MYSTERY COVE WATERPARK

DRC OVERVIEW - 2024 CURRENT PLAN

8 May 2024

MOA DEVELOPMENT
EXISTING

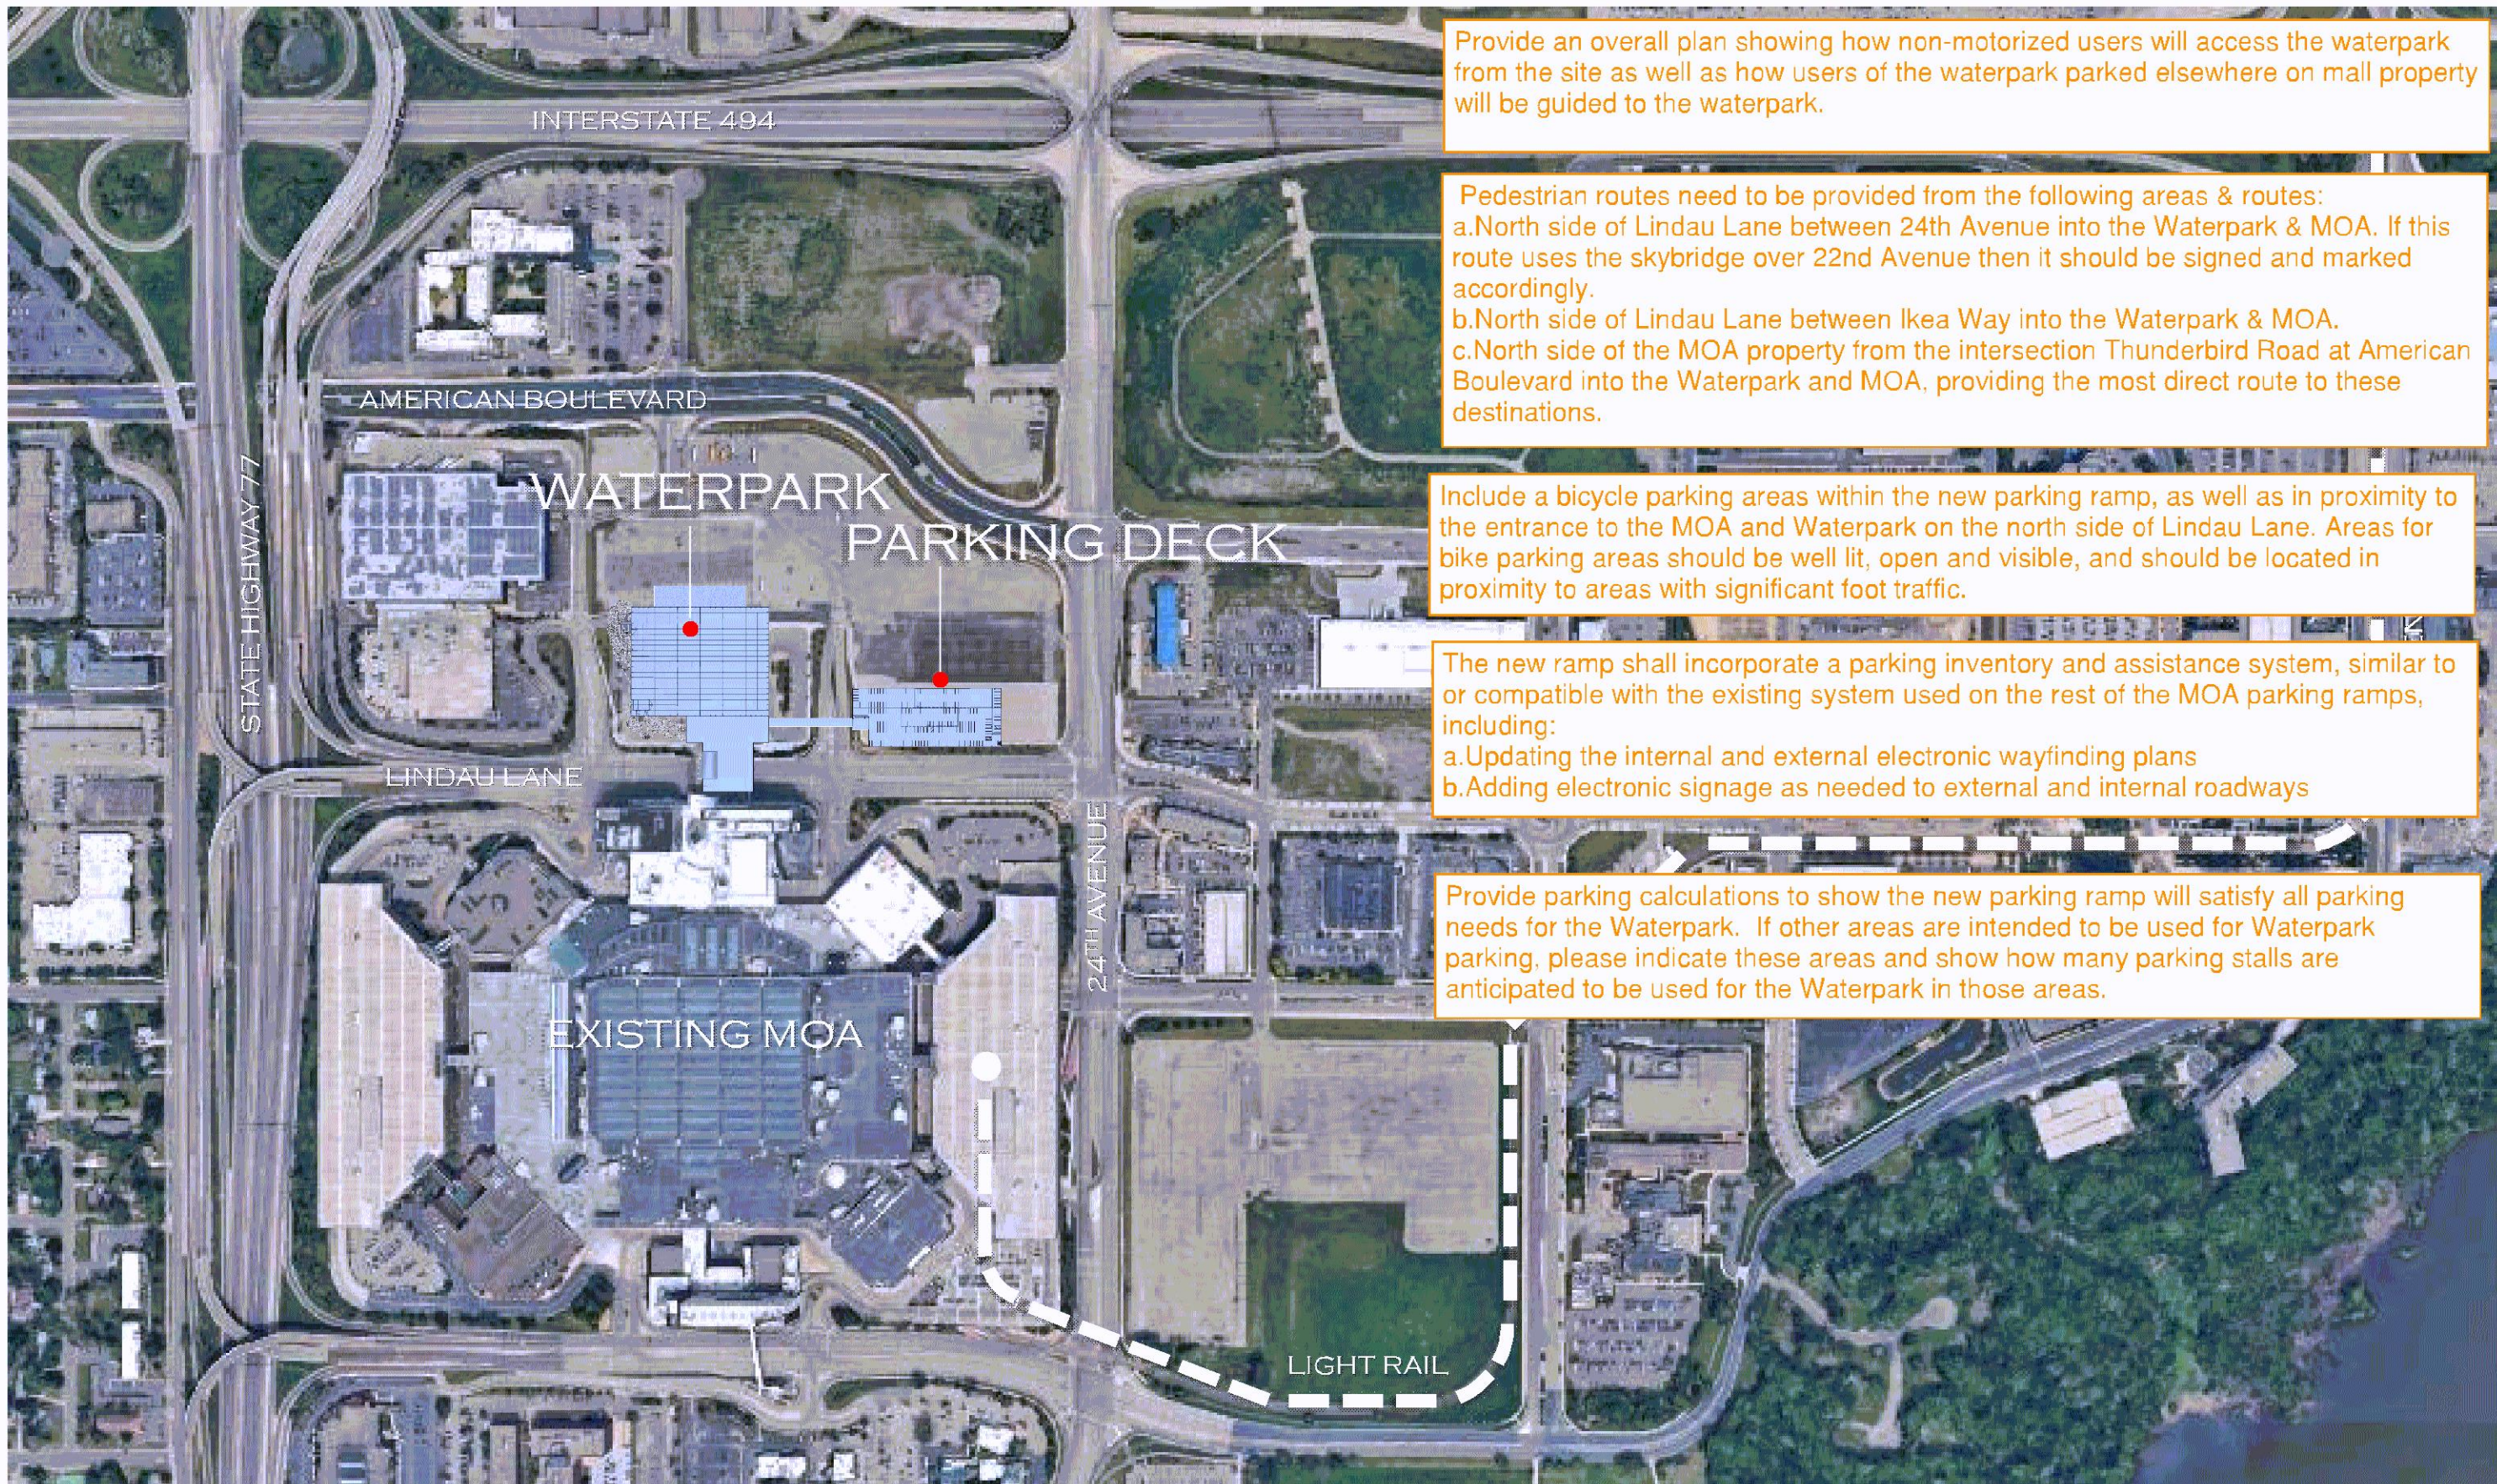
Provide an overall plan showing how non-motorized users will access the waterpark from the site as well as how users of the waterpark parked elsewhere on mall property will be guided to the waterpark.

Pedestrian routes need to be provided from the following areas & routes:
a. North side of Lindau Lane between 24th Avenue into the Waterpark & MOA. If this route uses the skybridge over 22nd Avenue then it should be signed and marked accordingly.
b. North side of Lindau Lane between Ikea Way into the Waterpark & MOA.
c. North side of the MOA property from the intersection Thunderbird Road at American Boulevard into the Waterpark and MOA, providing the most direct route to these destinations.

Include a bicycle parking areas within the new parking ramp, as well as in proximity to the entrance to the MOA and Waterpark on the north side of Lindau Lane. Areas for bike parking areas should be well lit, open and visible, and should be located in proximity to areas with significant foot traffic.

The new ramp shall incorporate a parking inventory and assistance system, similar to or compatible with the existing system used on the rest of the MOA parking ramps, including:
a. Updating the internal and external electronic wayfinding plans
b. Adding electronic signage as needed to external and internal roadways

Provide parking calculations to show the new parking ramp will satisfy all parking needs for the Waterpark. If other areas are intended to be used for Waterpark parking, please indicate these areas and show how many parking stalls are anticipated to be used for the Waterpark in those areas.

MOA DEVELOPMENT
PHASE IIC HOTEL

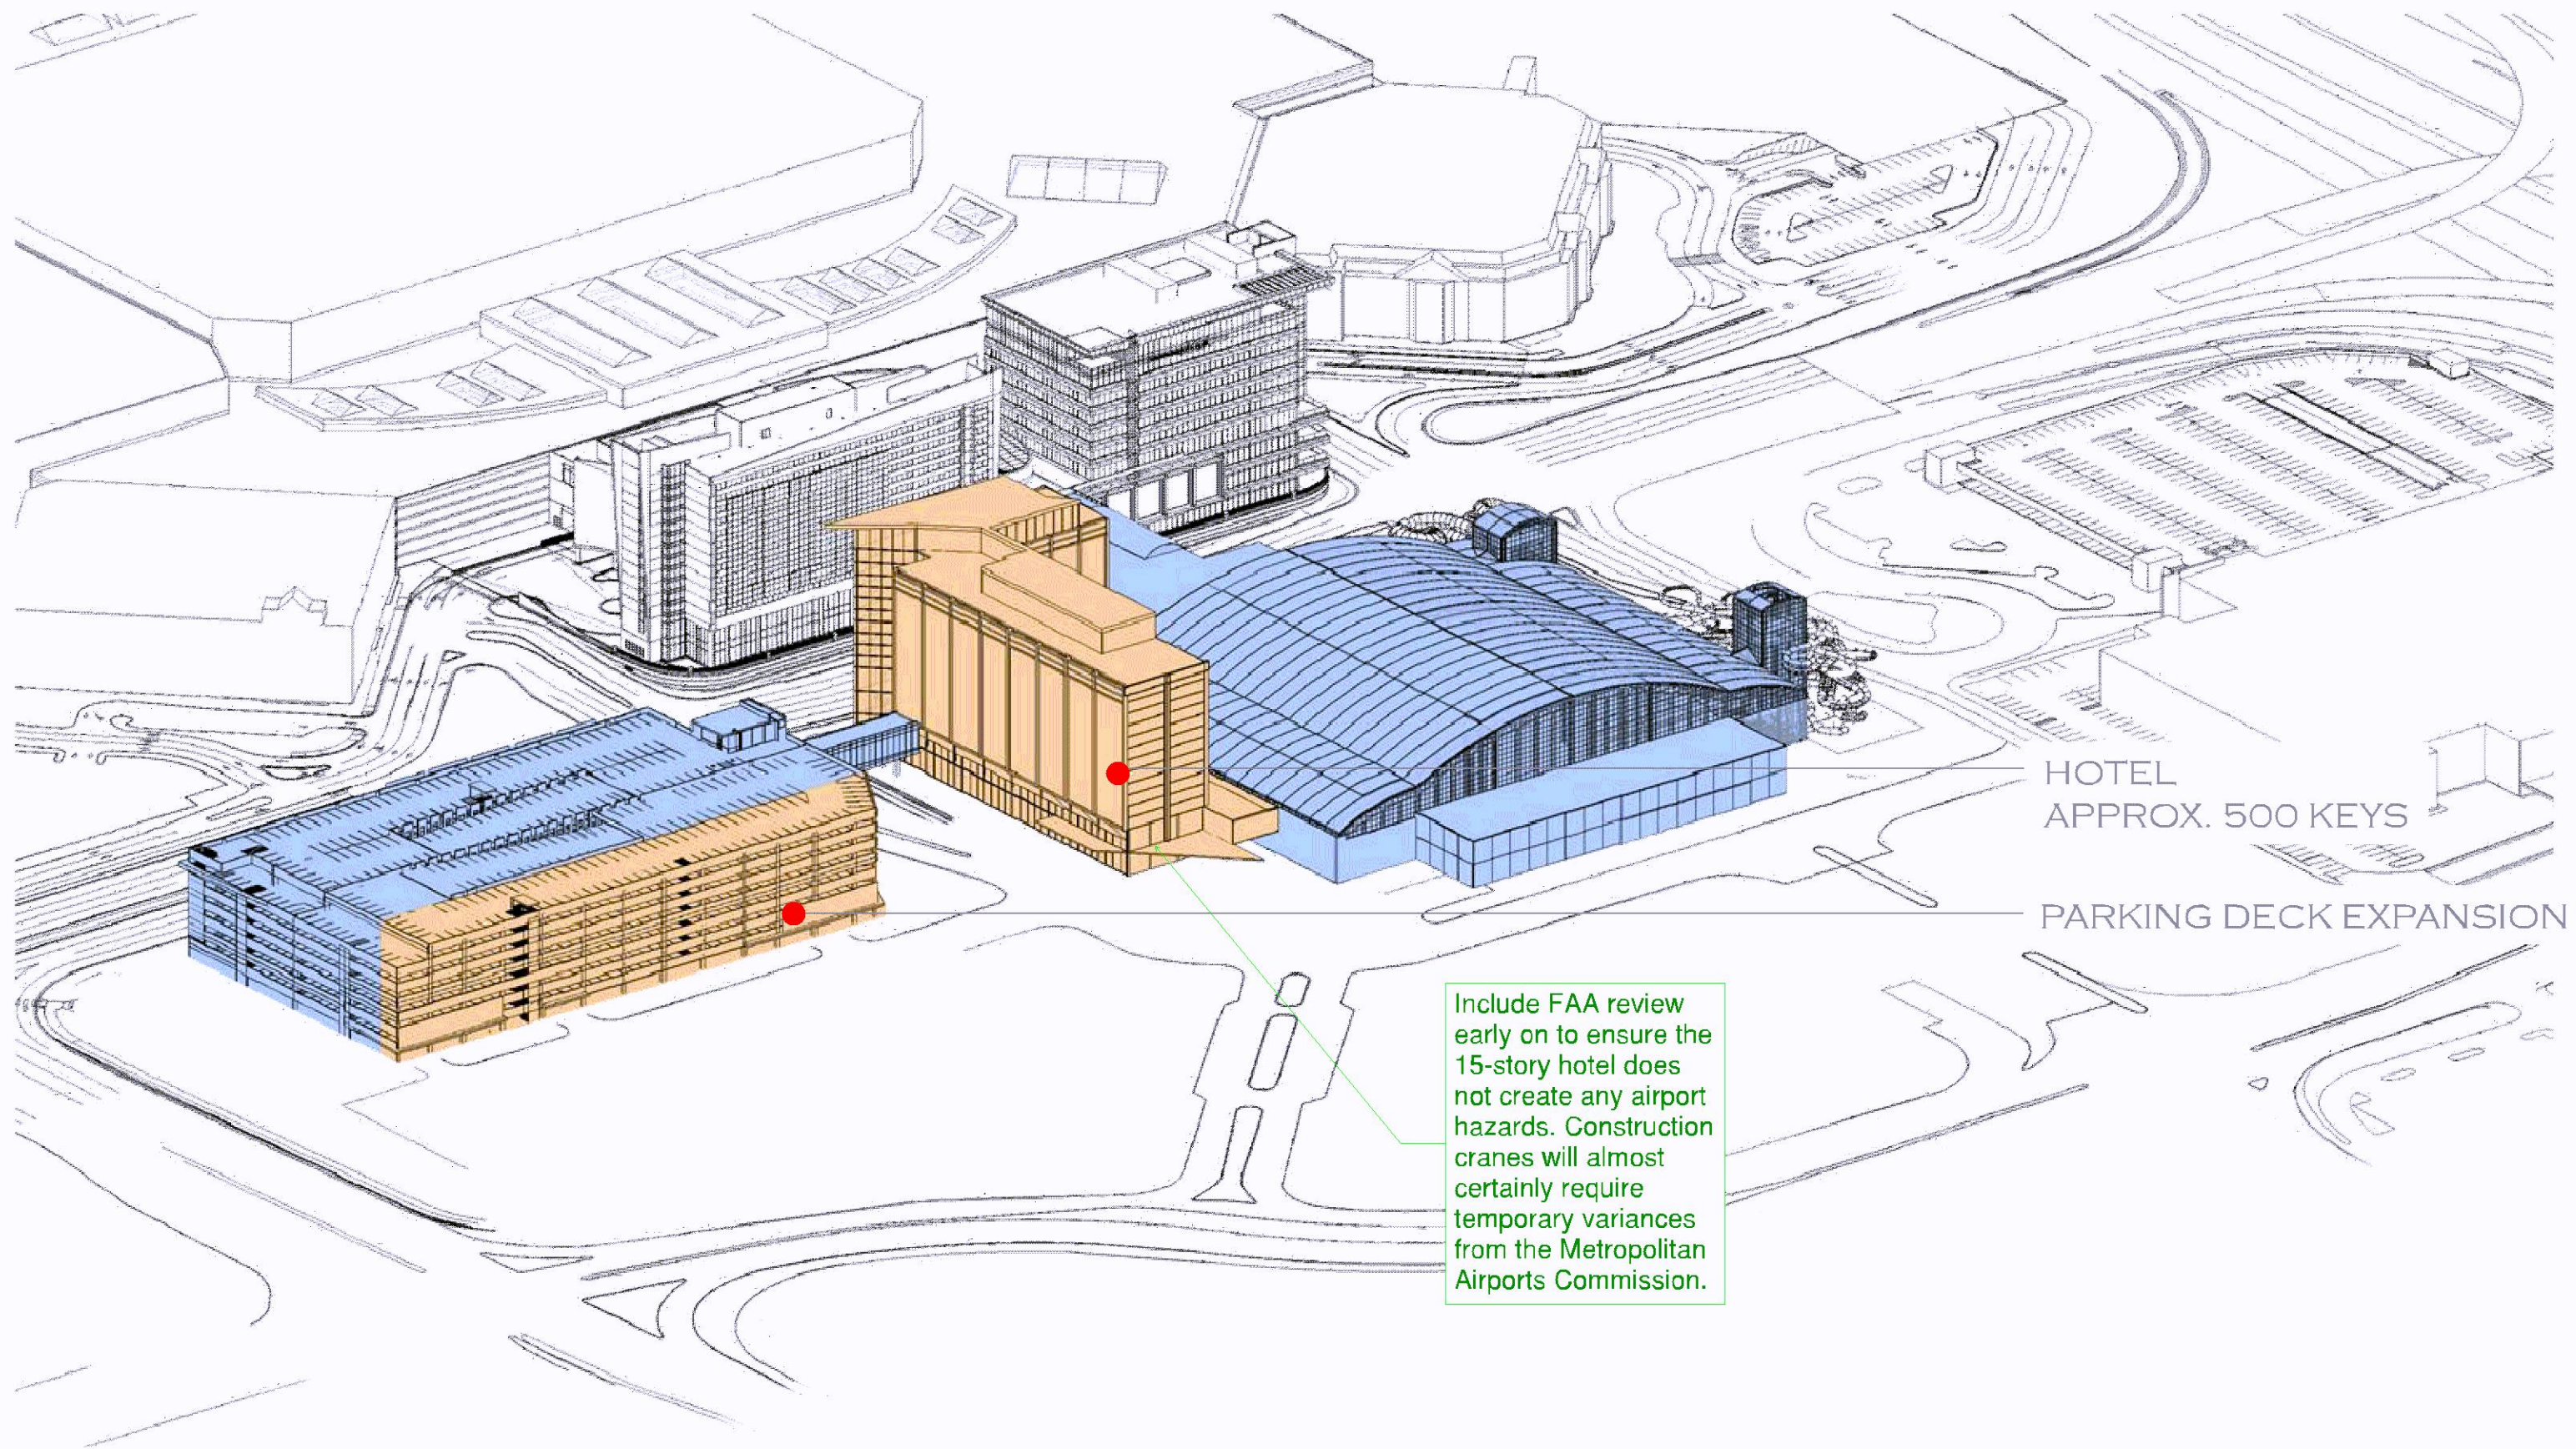
Include FAA review early on to ensure the 15-story hotel does not create any airport hazards. Construction cranes will almost certainly require temporary variances from the Metropolitan Airports Commission.
